This Response to Submission Statement relates to the transport impact assessment report. It is submitted to the Department of Planning, Housing and Infrastructure (DPHI) in support of the Response to Submissions (RTS) to the State Significant Development Application (SSDA) (SSD-82548708) for a residential flat building with infill affordable housing at 24, 26 and 28 Middle Harbour Road, Lindfield.

The Proponent has received feedback from the Department of Planning, Housing and Infrastructure (**DPHI**), Transport for NSW (**TfNSW**) and Ku-Ring-Gai Council (**Council**), following the submission of the transport impact assessment report as part of the EIS submission. The responses are identified and references are provided to show where they are addressed in this document.

Figure 1 Swept paths – B85 passing B99

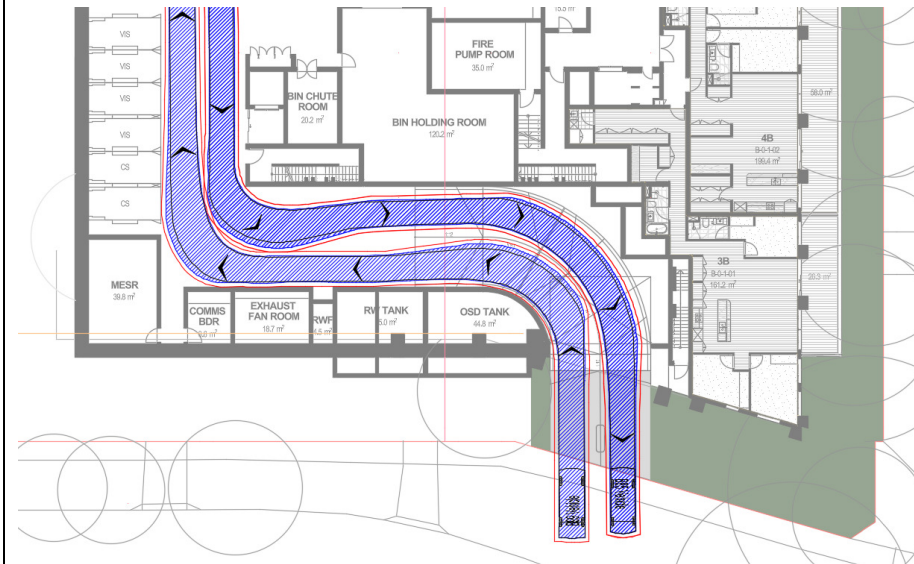
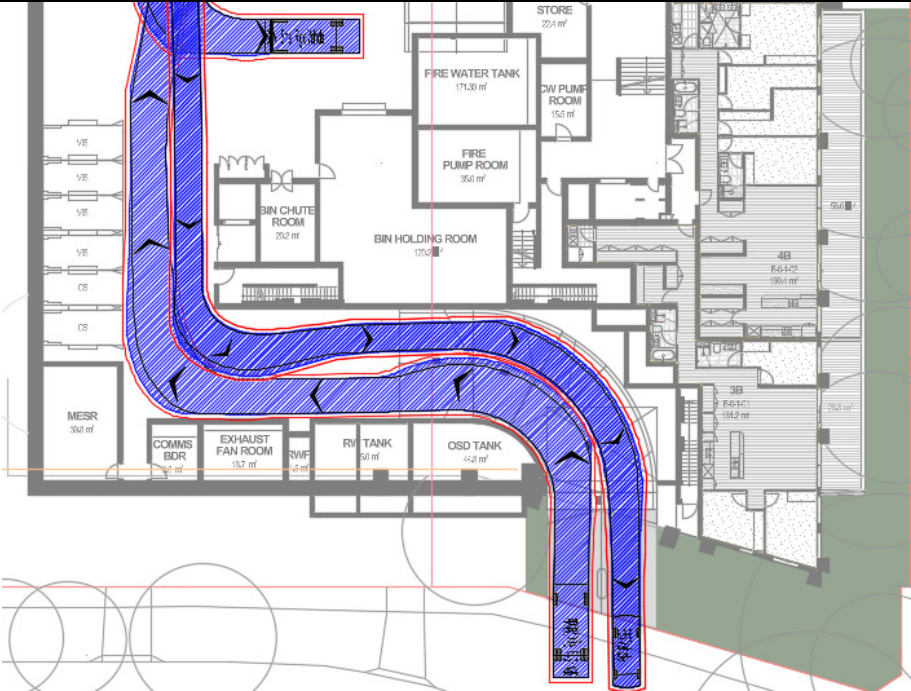
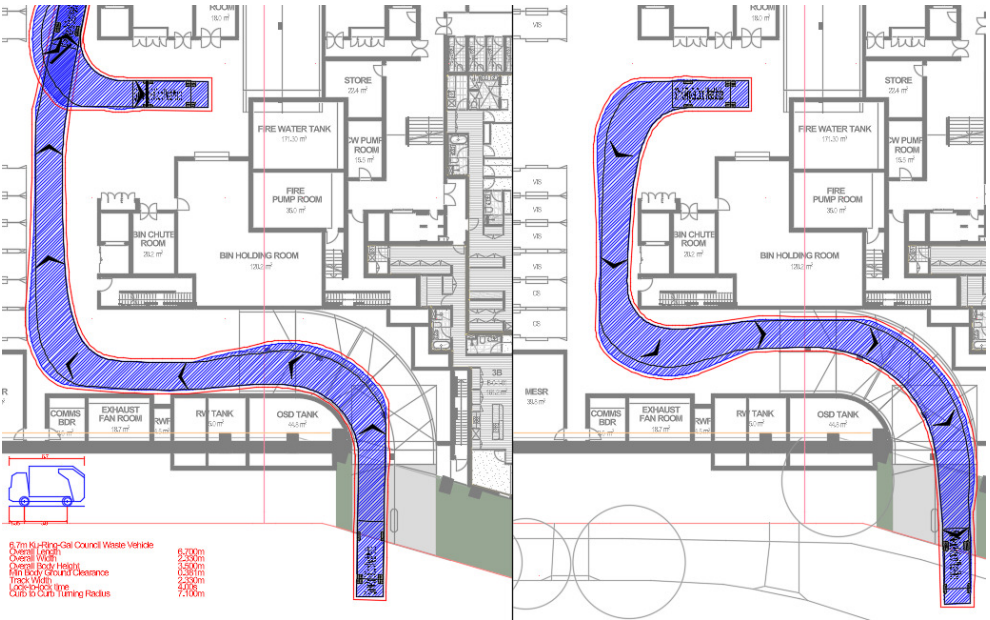
The swept path analysis indicates that Medium Rigid Vehicle (MRV) movements are likely to result in conflicts / overlap to the two-way movement of vehicles within the basement entrance ramp. Redesign the basement layout / access to address this issue or justify how these conflicts and potential safety implications can be ameliorated.

The amended basement design provides for simultaneous passing of a B99 vehicle and a B85 vehicle at all times as required under AS2980.1. This is shown in Figure 1 below.
